NANNY MARNO
COMMERCIAL KITCHEN REMODEL FOR
3367 APRES SKI WAY
STEAMBOAT SPRINGS, CO.
(970) 879-3092

Job No. 96-108
File MARNOCO
Date 1 NOV 96
Drawn ST
Checked JMH
Reid
Revised 15 NOV 96

RCRBD Record Set

KITCHEN PLAN

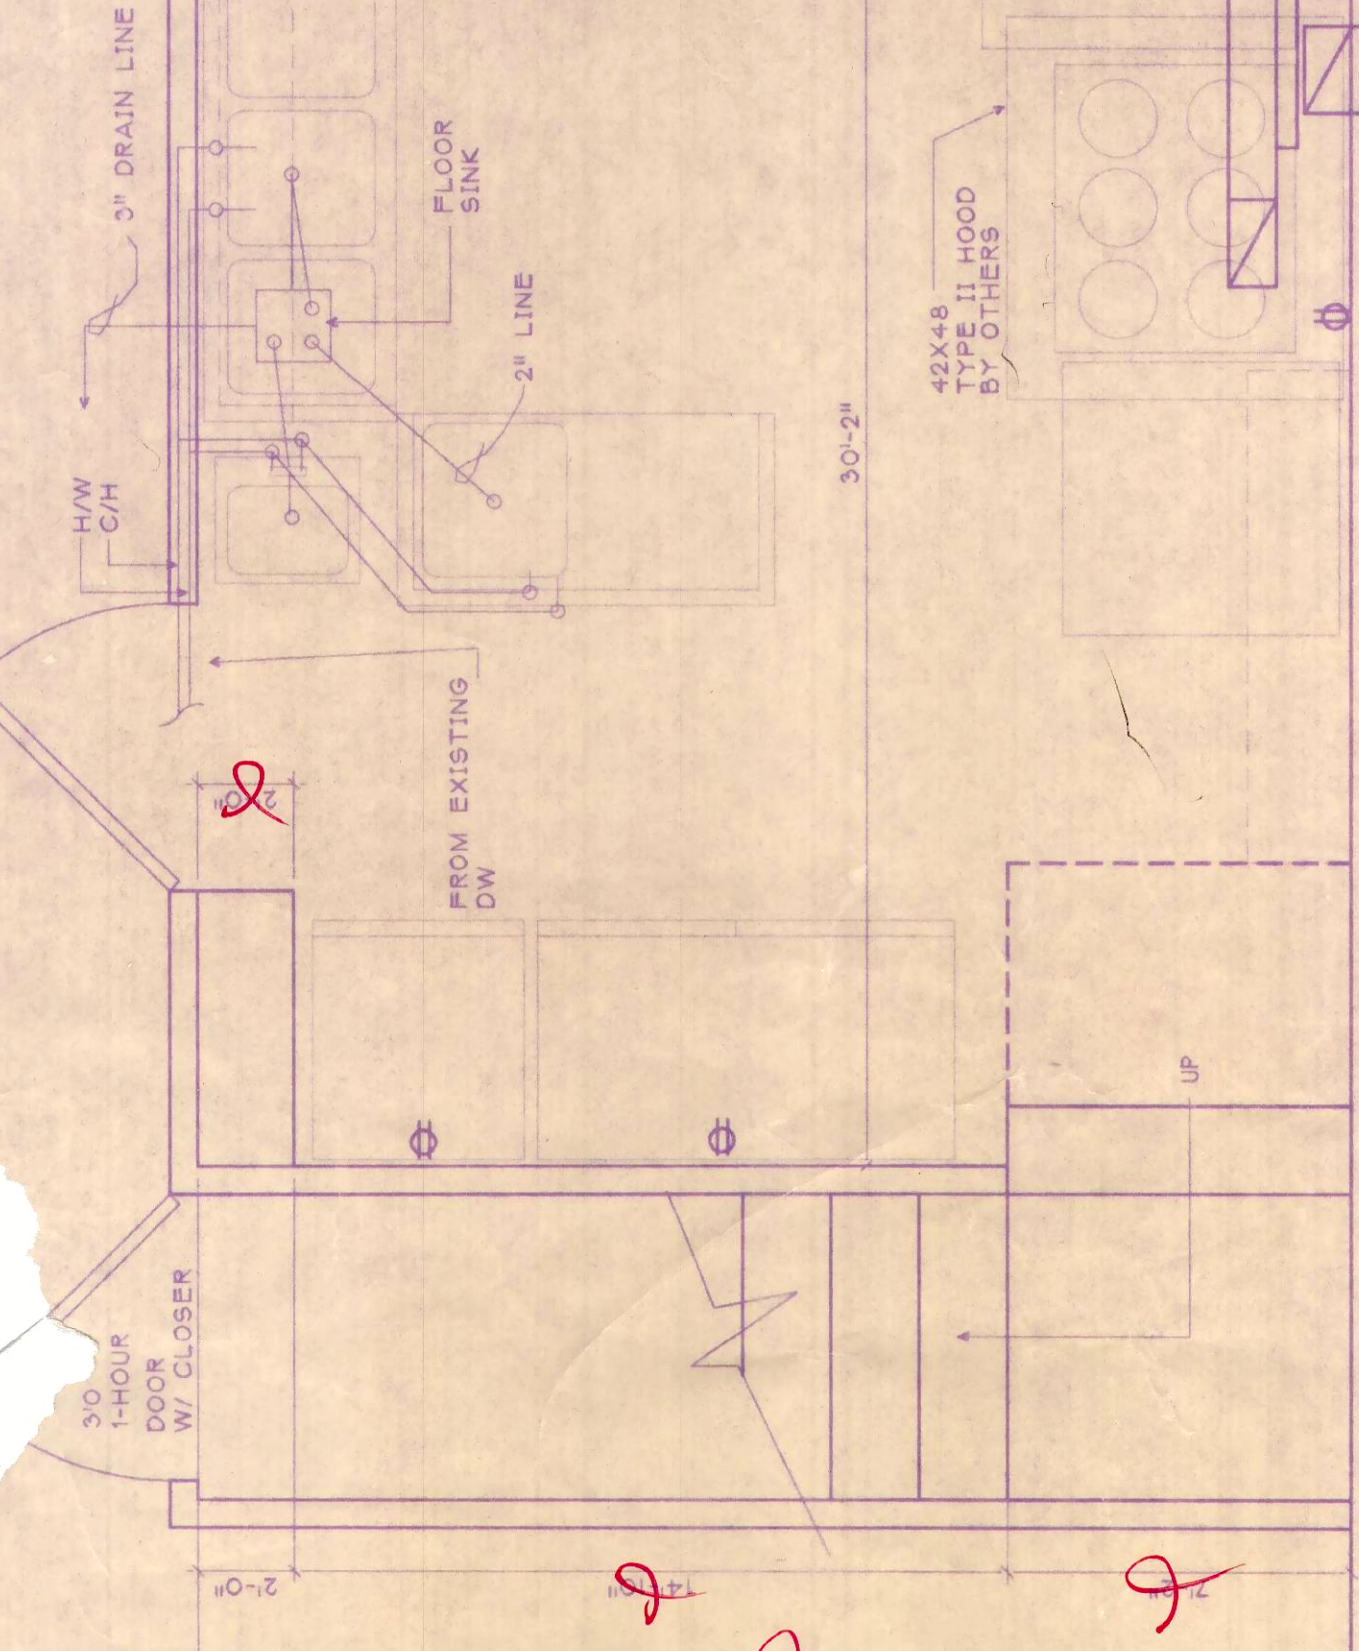
DIMENSIONS
per ATTACHED
REVISED

FLOOR PER
FC 5420

CEILING - (FIRE-RESISTIVE)
PER FC 5400 SEE ATTACHED
